U.S. Department
of Transportation
**Federal Highway
Administration**

In Reply Refer To:
HSSD/B-156

In your letter of December 13, 2006, you requested the Federal Highway Administration's (FHWA) acceptance of Single-Sided and Double Sided Thrie-Beam called the GMS-TB Guardrail System at the National Cooperative Highway Research Program (NCHRP) Report 350 test level 3 (TL-3). To support your request, your company sent a copy of the Southwest Research Institute report dated November 30, 2006, entitled "NCHRP Report 350 Test 4-11 Full-Scale Crash Evaluation of a Single-face GMS-TB Guardrail System" and digital videos of the crash test conducted on the GMS-TB Guardrail System. You also requested the waiver of tests 3-10 of the Single-Sided and Double Sided GMS-TB Guardrail System and test 3-11 of the Double-Sided GMS-TB Guardrail System.

GREGORY MINI SPACER

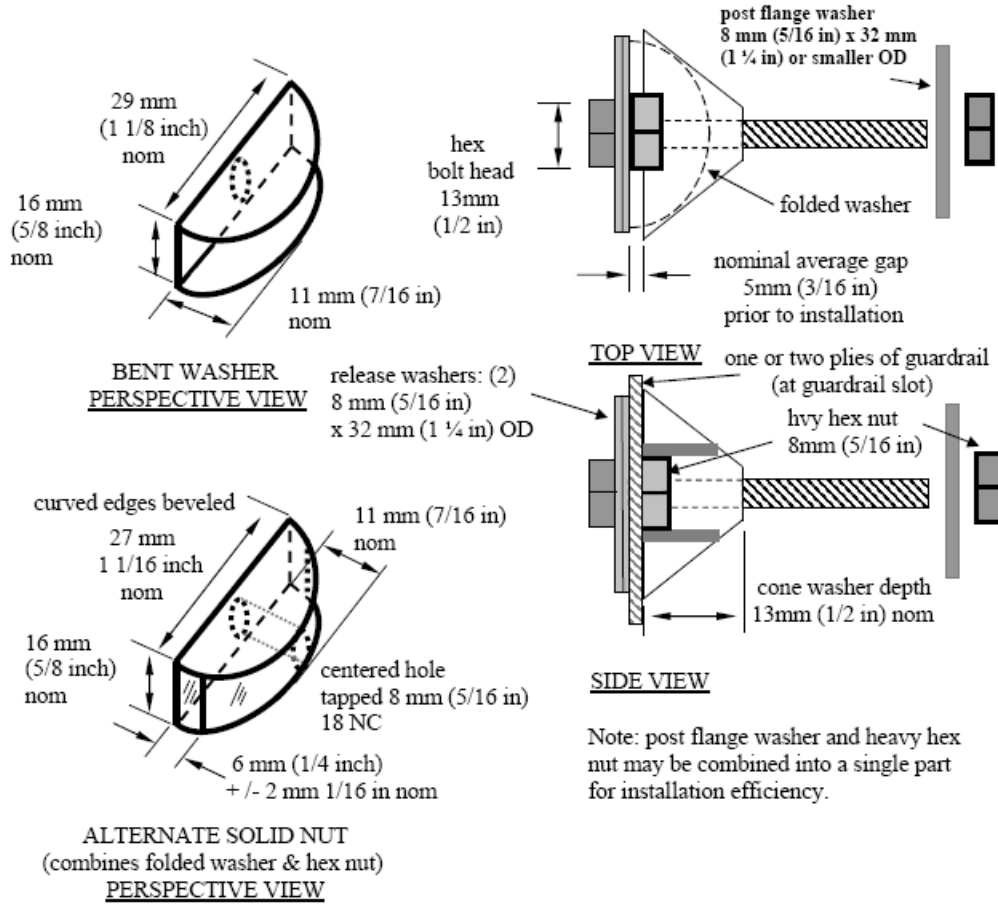
SGR09 (a,b,c) Thrie-Beam systems and accounts for higher centers of gravity of the current vehicle fleet. The ground clearance of the system is 483 mm (19 in), which is the same ground clearance that was used in the W-beam GMS designs previously accepted by the FHWA (acceptance letter HSA-10/B150). The proprietary GMS fastener is a critical element of the system. It ensures that Thrie-Beam panels disengage from the posts on impact and are not pulled down to the ground and rotated by the posts. Such performance lowers the probability of vehicles overriding the system. Also, posts disengaged from the guardrail have less of a snagging potential compared to posts attached to the guardrail. Design details for the proprietary GMS fastener are shown in Enclosure 1.

Figure A.1 – Gregory Industries Single-Face GMS-TB Guardrail System

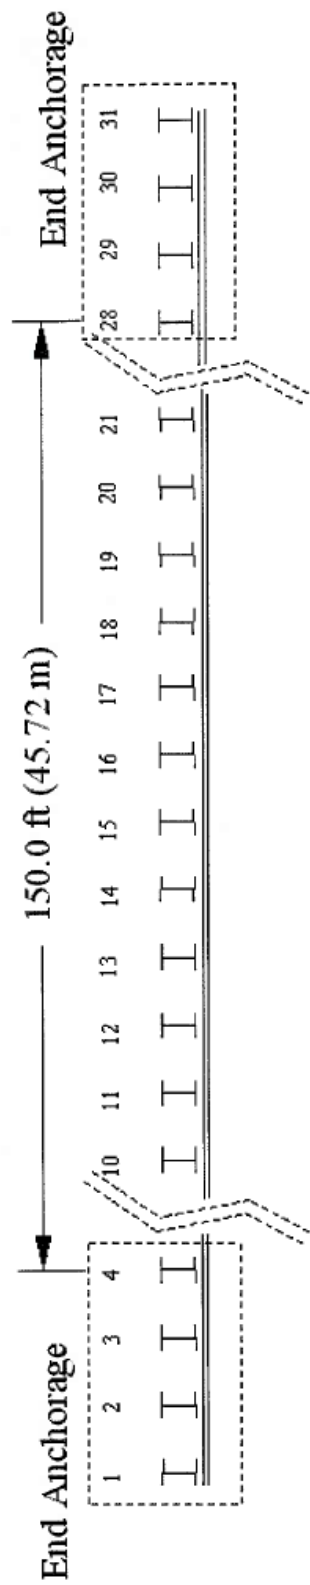
The GMS-TB Guardrail System is a Thrie-Beam longitudinal barrier which uses 12-gage Thrie-Beams mounted directly on conventional W6 x 8.5 posts without blockouts or backup plates at any of the posts. The Thrie-Beams are attached to the posts with a single proprietary Mini Spacer (GMS) fastener at each post, with the fastener being attached to the Thrie-Beam at the lower flange of the Thrie-Beam (using a 0.64 m (25 in.) mounting height). All guardrail splices are located at posts. The guardrail panels are each 3.81 m (12.5 ft) long, the posts are spaced at 1.91 m (6.25 ft), and the height of the top of the guardrail is 0.99 m (39 in). This height constitutes an increase of approximately 100mm (4 in) compared to the conventional

The test article's length-of-need section was 45.72 m (150 ft) long. The 12 guardrail panels between the end anchors were each 3.81 m (12.5 ft) long, the posts were spaced at 1.91 m (6.25 ft), and the height of the top of the guardrail was 0.99 m (39 in). The barrier system was terminated at either end with modified Type T Anchors (Foundation Tube Option), without blockouts, and without struts between posts. This end anchor is designed to span three posts. However, rectangular washers were added at posts 1 through 4 and 28 through 31 for purposes of this length-of-need test only. Drawings of the test article are presented in Enclosure 1. Note that the end anchor systems were assembled as shown, except that Thrie-Beam rails were used in place of the W-Beam rails and the anchor cable bracket was attached to the lower flange of the Thrie-Beam rail.

The GMS-TB Guardrail System performed as intended. In the posts that were directly contacted by the test vehicle (Posts 13 through 19), the guardrail was released from the posts. In the vehicle contact region, all of the fasteners were sheared at the front face of the post during the impact of the vehicle with the guardrail and posts, except for Post 16 where the fastener was not sheared. All of these fasteners exhibited a uniform U-shaped deformation of the release washers. Outside of the vehicle contact region, the fasteners in Posts 20 through 24 released from the guardrail without being sheared, and in Post 25 the fastener released from the guardrail and was sheared at the front face of the post. These fasteners also exhibited a uniform U-shaped deformation of the release washers. None of the Thrie-Beams failed and all of the splice joints remained fastened together. The guardrail was not smashed flat at any of the posts in the impact region and for the most part maintained its Thrie-Beam shape.

In summary, I agree that both Single-Sided and Double Sided GMS-TB Guardrail Systems, as described above, meet the appropriate evaluation criteria for NCHRP 350 TL-3 devices and may be used at all appropriate locations on the National Highway System (NHS) when selected by the contracting authority, subject to the provisions of Title 23, Code of Federal Regulations, Section 635.411, as they pertain to proprietary products.
